**TOWN OF MOUNTAIN VILLAGE
REGULAR DESIGN REVIEW BOARD MEETING
AGENDA**

THURSDAY MARCH 4, 2021 10:00 AM

TO: Mountain Village Design Review Board
FROM: John Miller, Senior Planner
FOR: Design Review Board Public Hearing; March 4, 2021
DATE: February 19, 2021
RE: Staff Memo – Final Architectural Review, Lot BC513E

1
A104- BASEMENT EXTERIOR LIGHTING PLAN
1/8" = 1'-0"

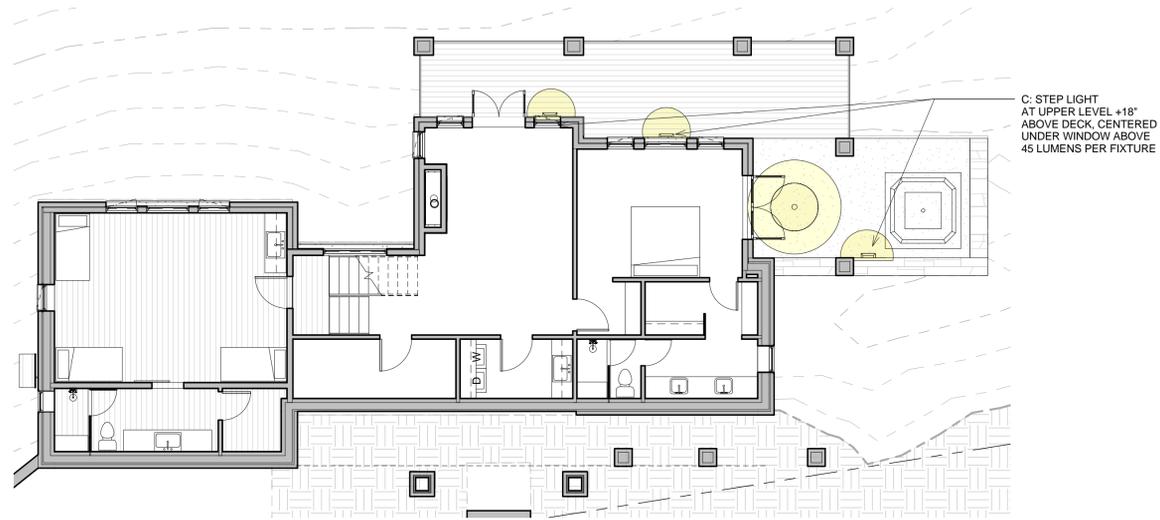
Staff: The applicant has provided a lighting plan demonstrating the locations and types of fixtures. The applicants have revised their lighting plan to remove the majority of the

Staff: The applicant has modified their lighting plan in a way that has minimized lighting along the east and north facades of the home. Staff believes that this criteria is now being met based on the revisions.

CORRECTED LIGHTING PLANS- REMOVED OLD NOTE AND ADDED NOTE DESCRIBING ADDRESS MONUMENT LIGHTING

PROJECT NAME: LOT BC513E
SHEET DESCRIPTION: ENTRY LEVEL PLAN
SHEET NUMBER: A202

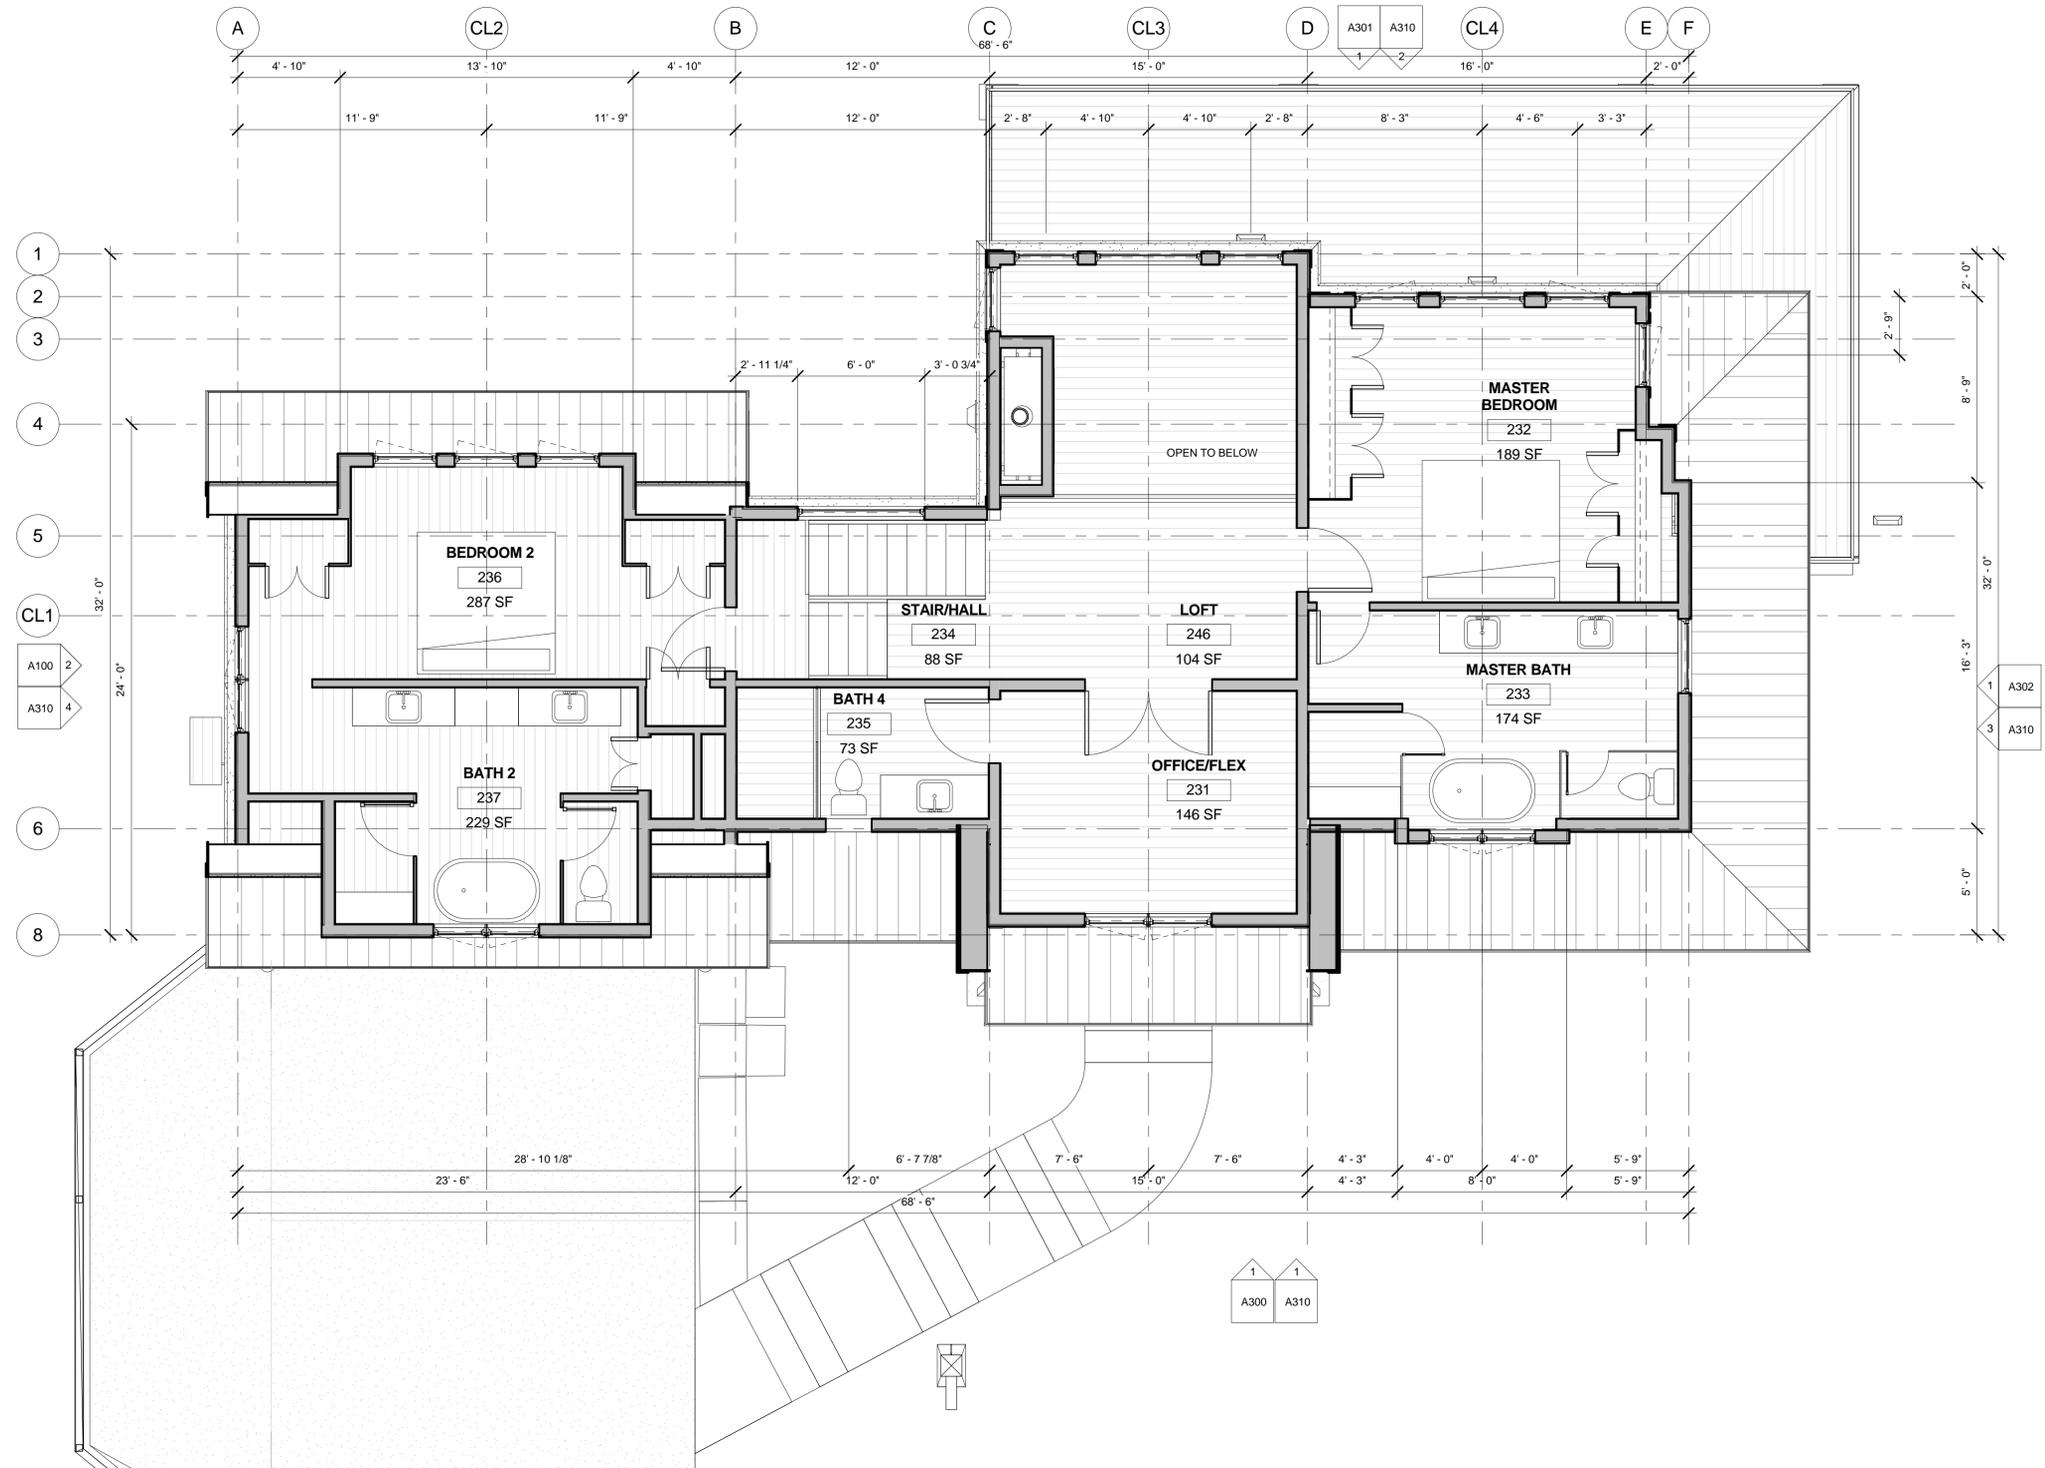
Staff: The CDC requires all single-family developments to provide two interior and two exterior parking spaces. The applicant has shown a total of 2 interior spaces on Page A202 but has not provided for the exterior spaces within the plan set. Based on the Construction Mitigation Plan, it appears that there is room for 2 exterior parking spaces within the Southern GE but the DRB will need to determine if this is appropriate per the comments discussed above related to GE encroachments. The CDC also requires that all parking spaces have direct access from the road as well as requiring that garages designed to have cars backing out have a minimum of twenty-five feet of backup space. For single-family review, the DRB may allow for tandem parking spaces as the two surface spaces for lots smaller than 0.75 acres where non-tandem parking is no feasible due to unique site conditions such as steep slopes, and may waive the two surface spaces for smaller lots when tandem is not feasible.

① 3 EAST ELEVATION
1/4" = 1'-0"

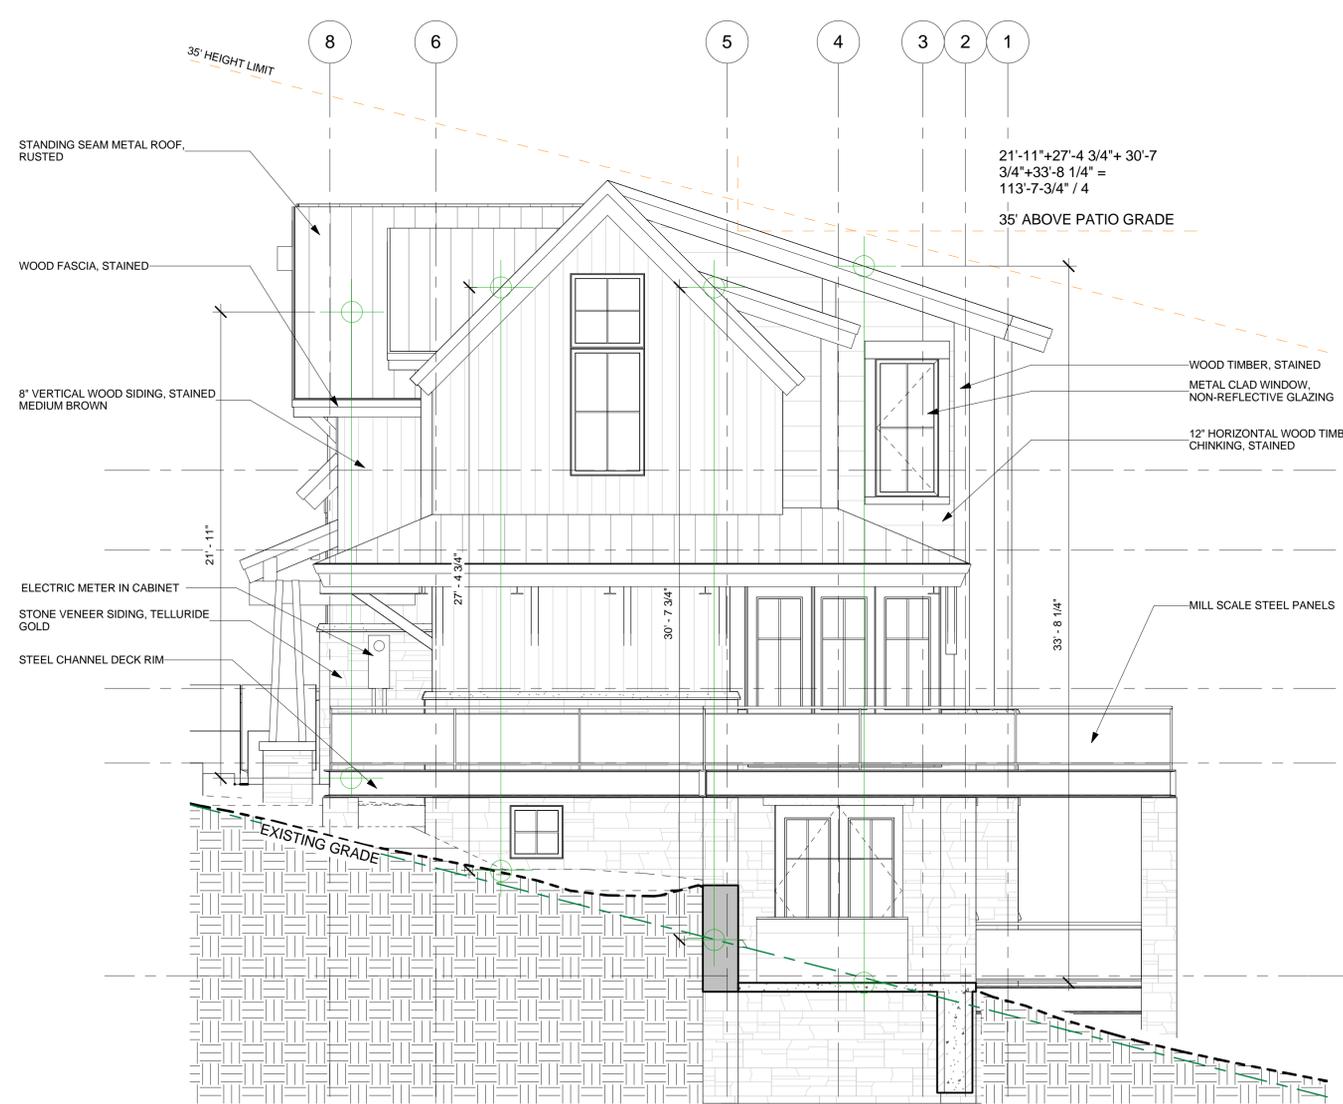
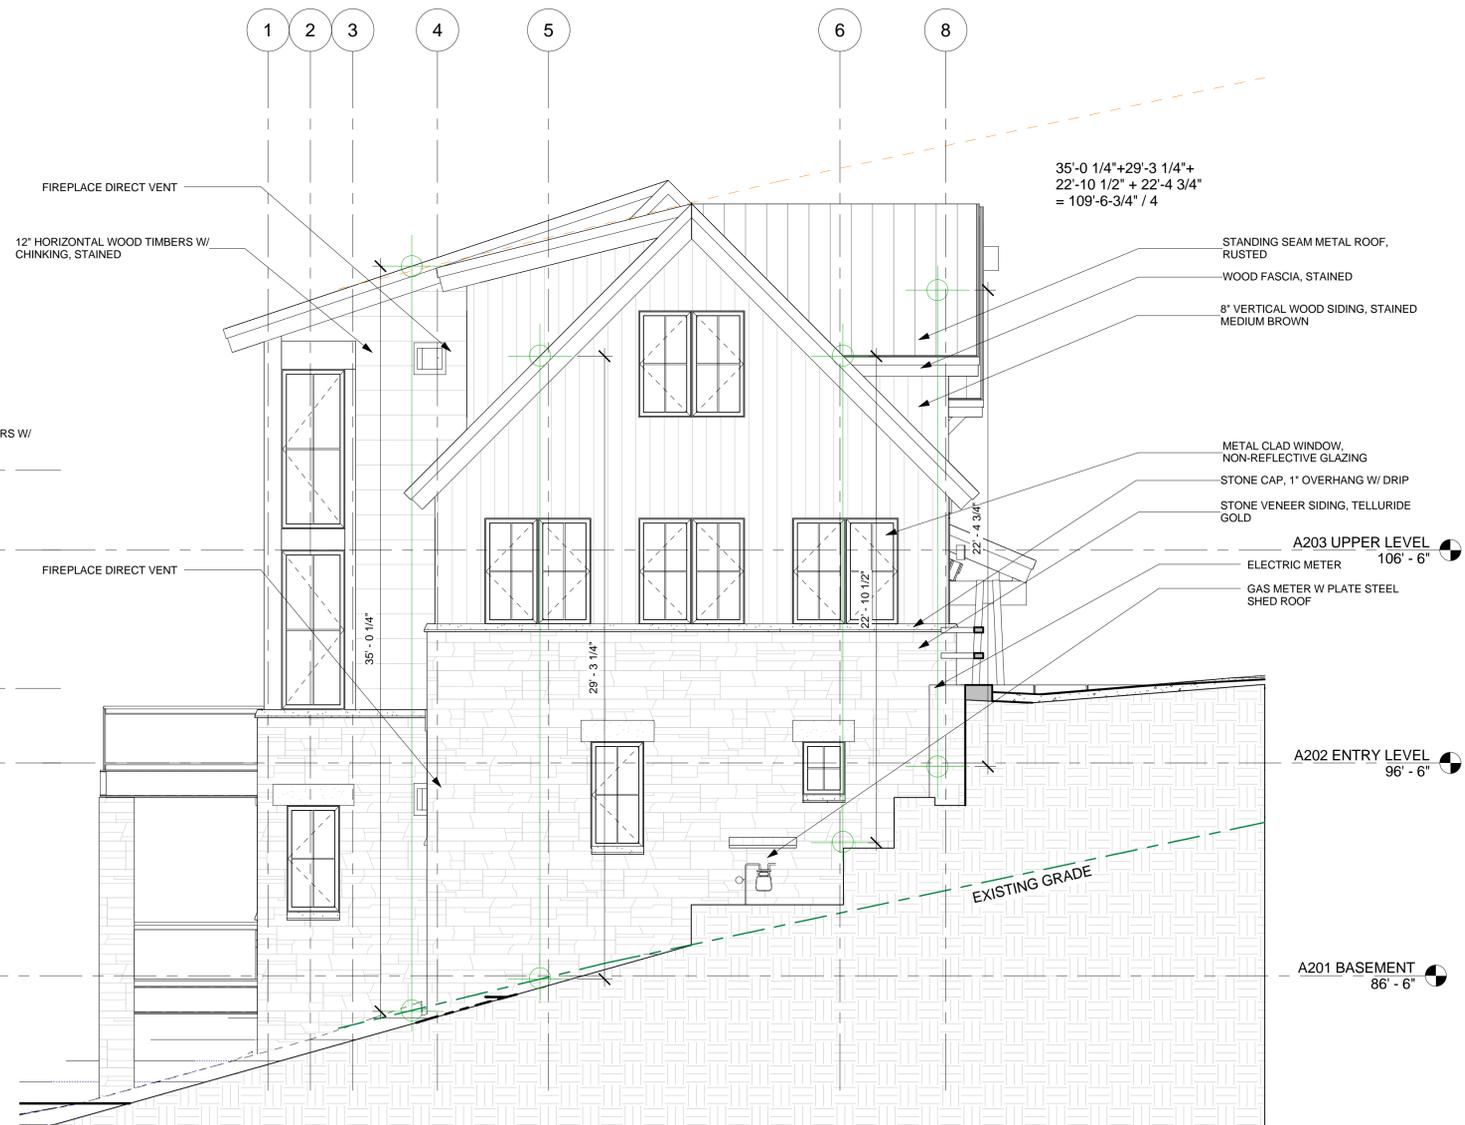
Staff: As part of this application, the applicant has provided both a Maximum Building Height and Average Building Height calculation on pages A300 – A302 and shown above in Table 1. Since the January hearing, the applicant has revised the plans to demonstrate

the most restrictive grade in their parallel slope analysis and it appears that a very small portion of the roof is within the 35-foot plane on the east elevation of the home. It should be noted that this home – given the primary gabled roof forms is allowed a 40-foot maximum building height, and the proposed design is well within that allowance.
